City of Franklin

Meeting Agenda

Historic Zoning Commission

Monday, October 13, 2025

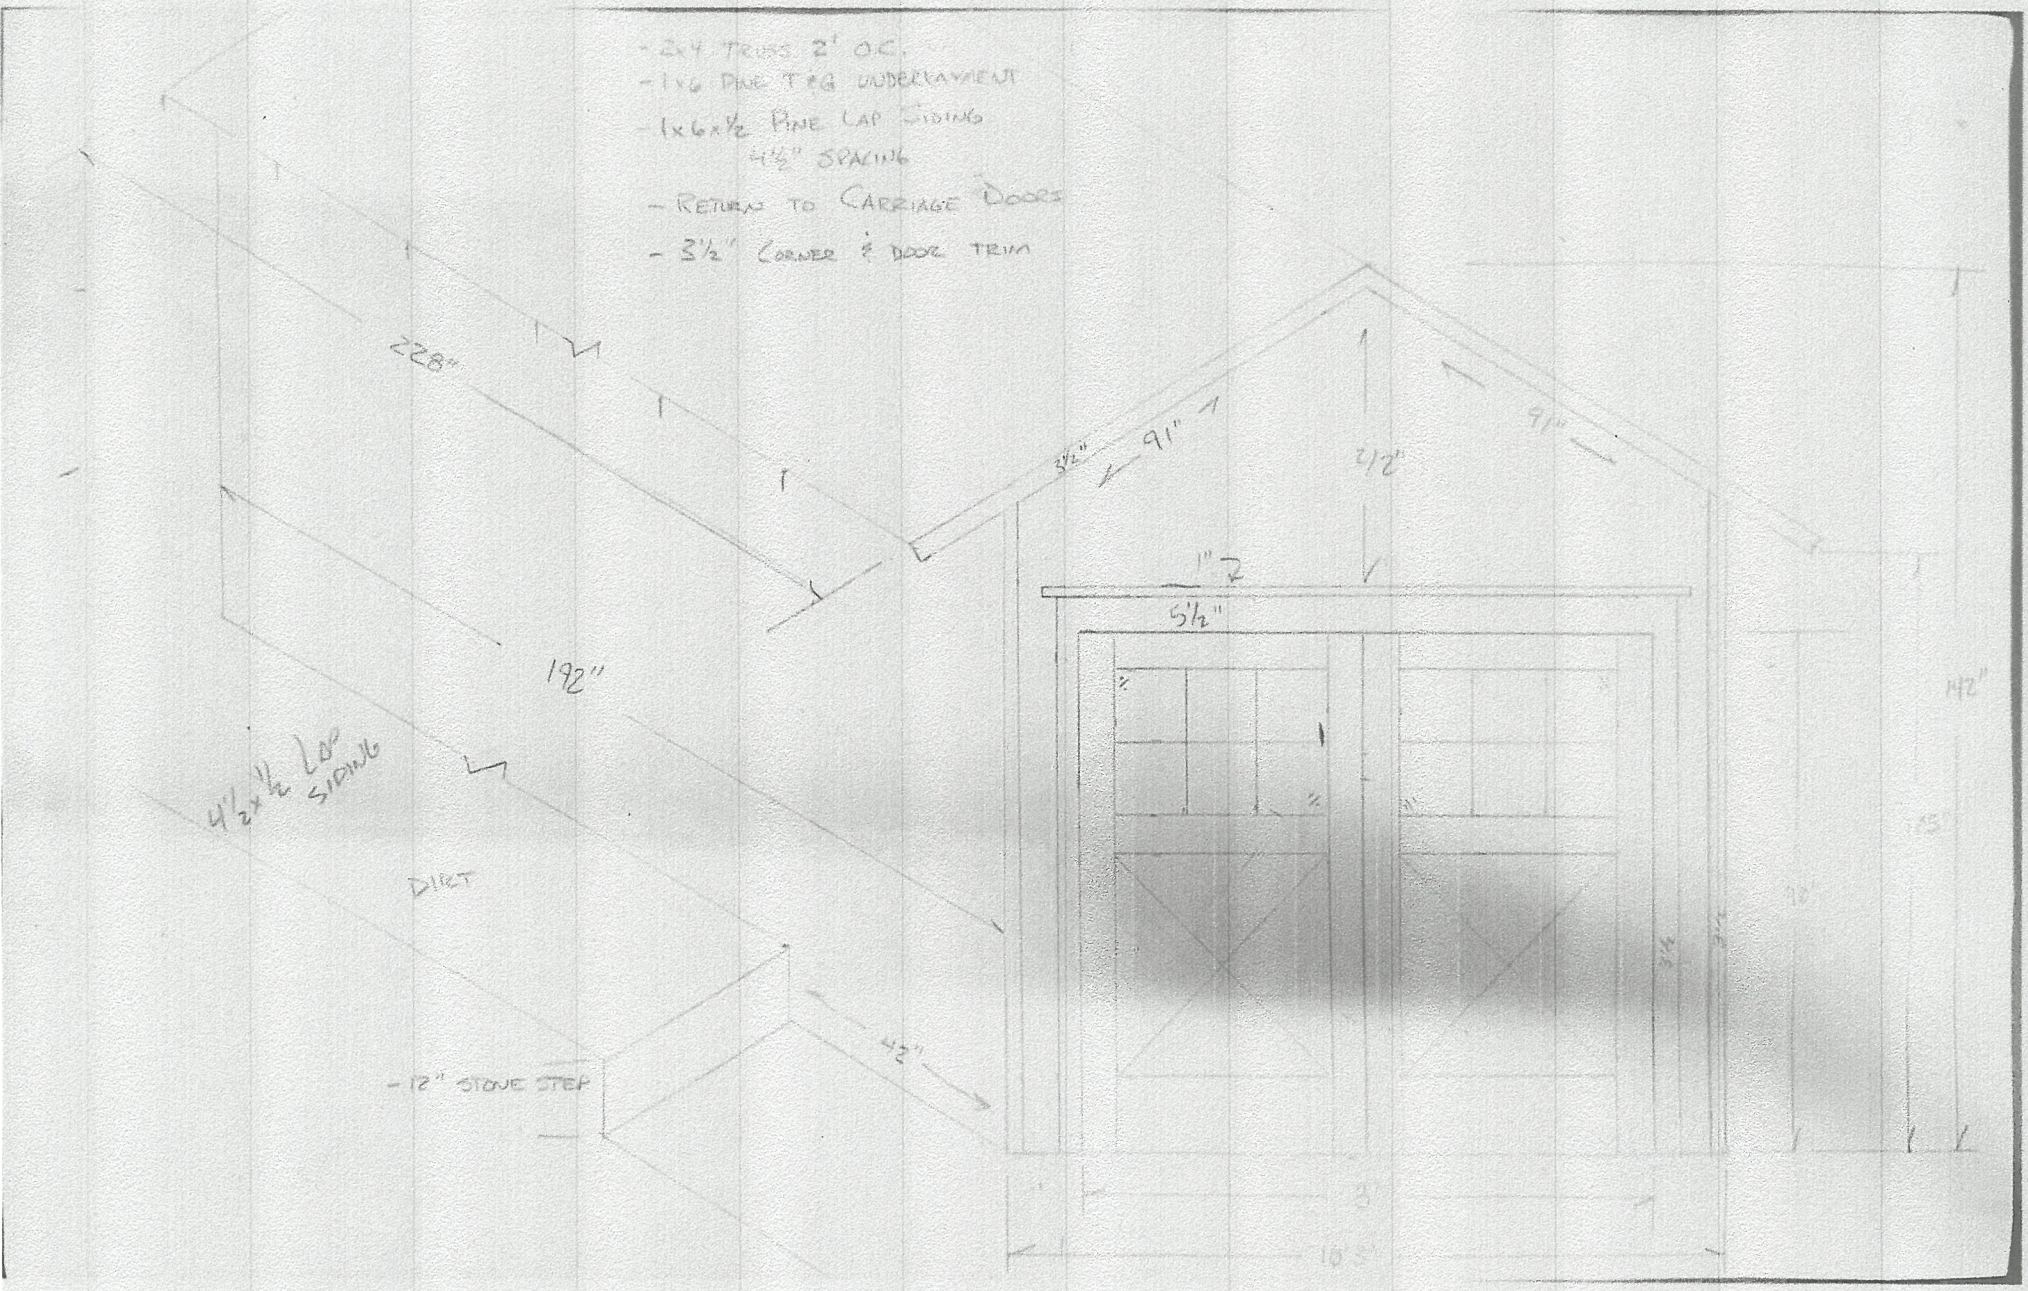
The existing garage doors are sliding glass doors. It is proposed to replace the existing doors with a door design that was previously used on the structure. The carriage style doors utilize a six-window-lite pattern on the top of each door and a crossbuck design on the bottom of each door. The Guidelines recommend:

2. Any additional changes to the approved plans must be returned to the Preservation Planner or the Historic Zoning Commission for review and approval.

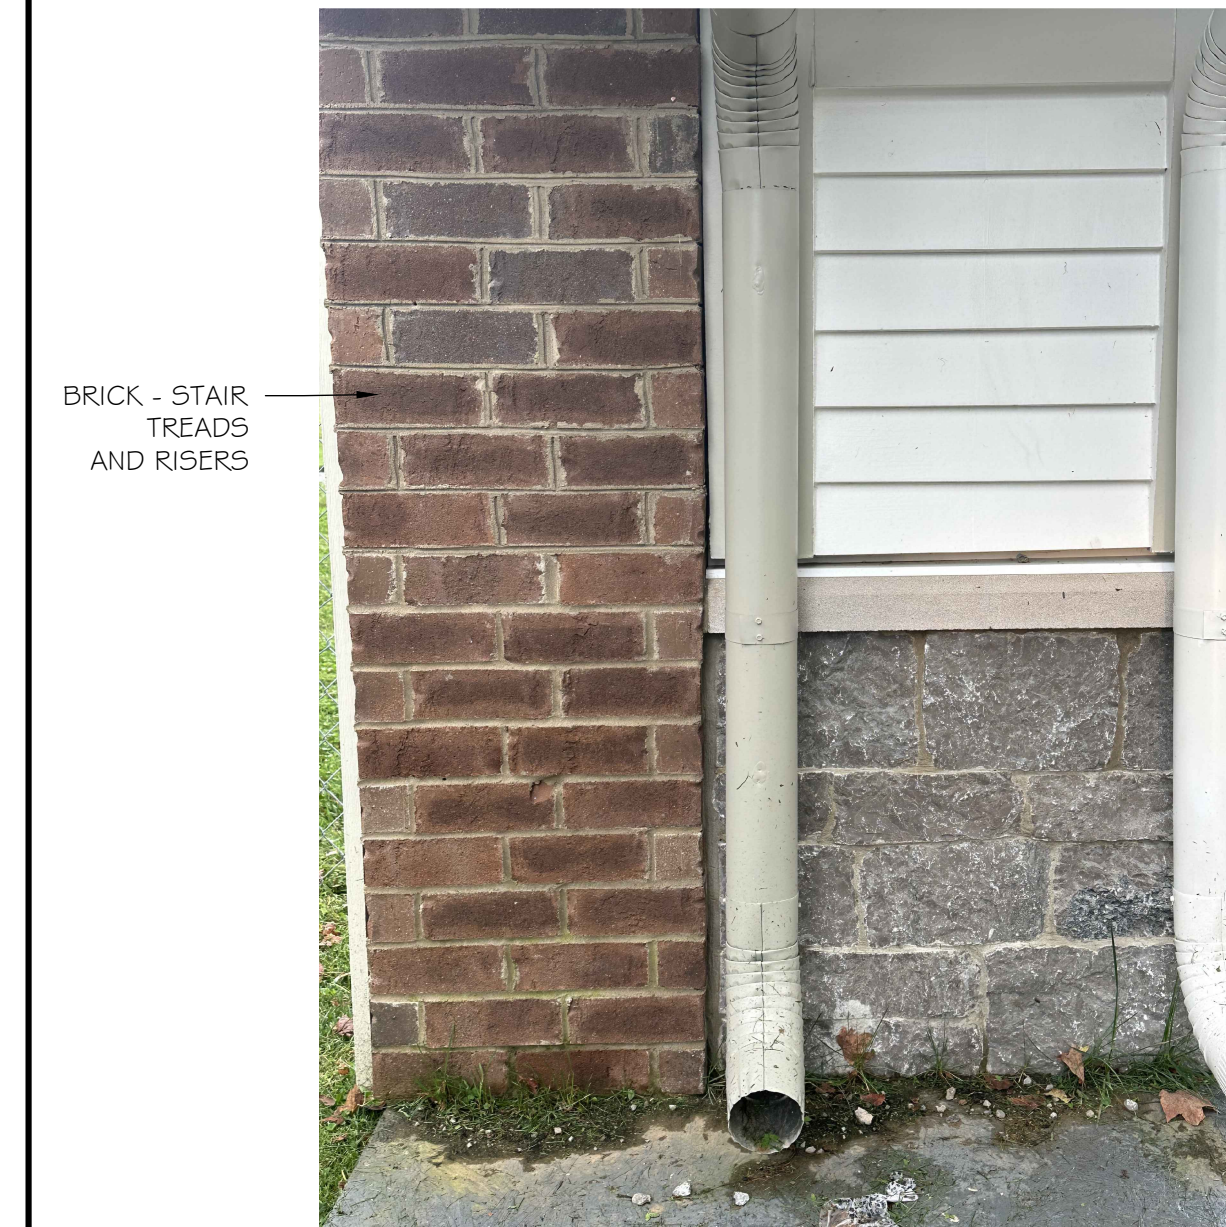
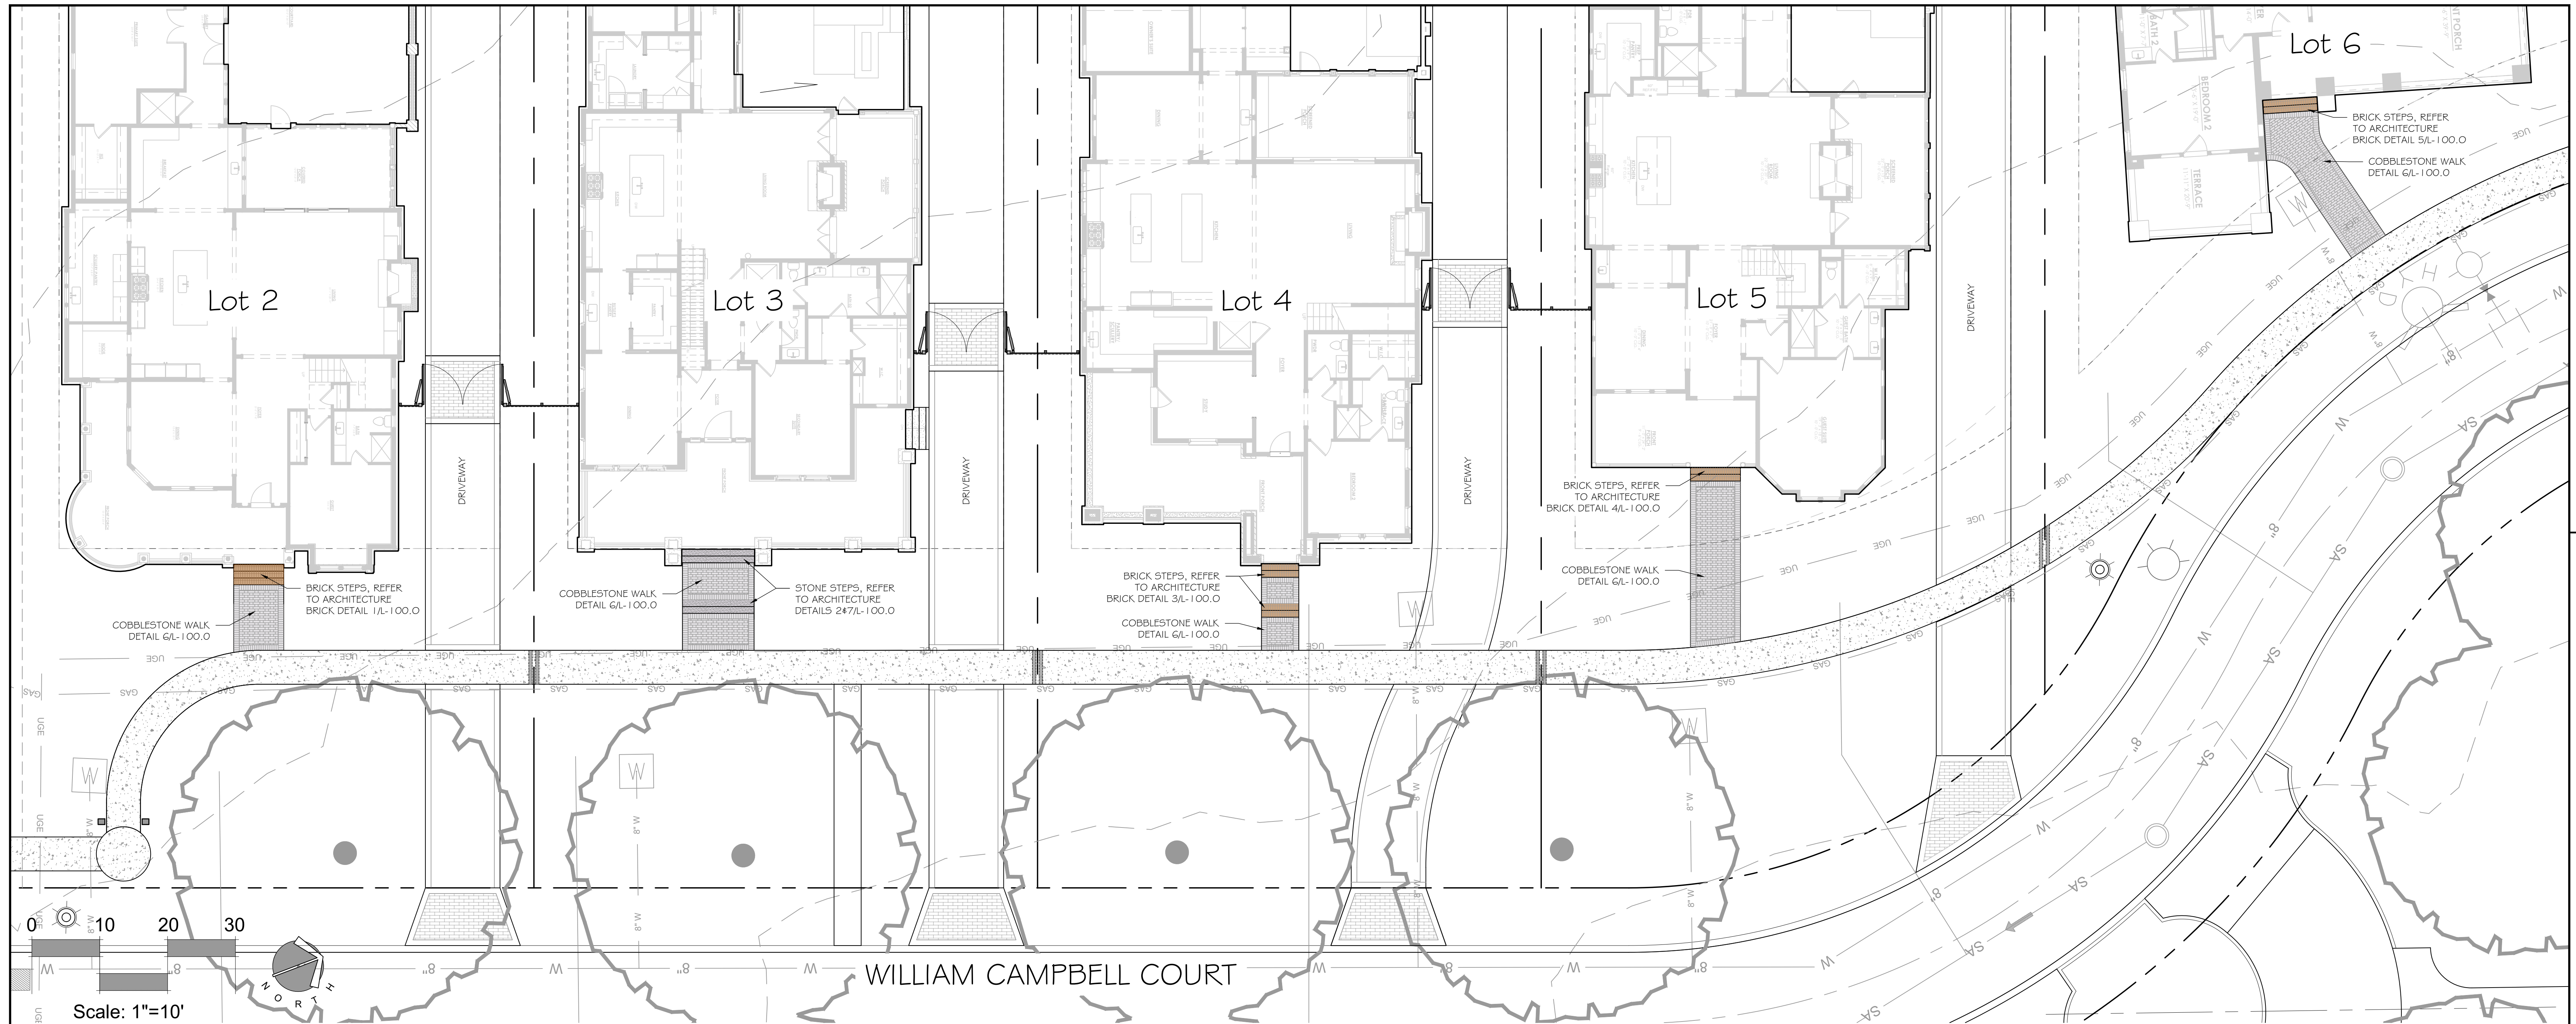
The proposal includes a change in the walkway material to be cobblestone. This material would be used from the sidewalk to the front porch of each building. The steps in the path of the walkway on each lot will utilize either stone or brick, depending on the materials approved for the building. The path of the walkway has been altered. The Guidelines recommend the following:

- New sidewalks and walkways should follow historic patterns of alignment, configuration, width, and materials.

brick, stone, and concrete. The historicity of these materials is not known, but they are commonly seen. While cobblestone is a less common stone within the district, it is a stone material that is of high quality. The use of stone for the walkway materials for the properties is appropriate.

1. The application must meet all the requirements of the City of Franklin prior to issuance of a building permit.
2. Any additional changes to the approved plans must be returned to the Preservation Planner or the Historic Zoning Commission for review and approval.
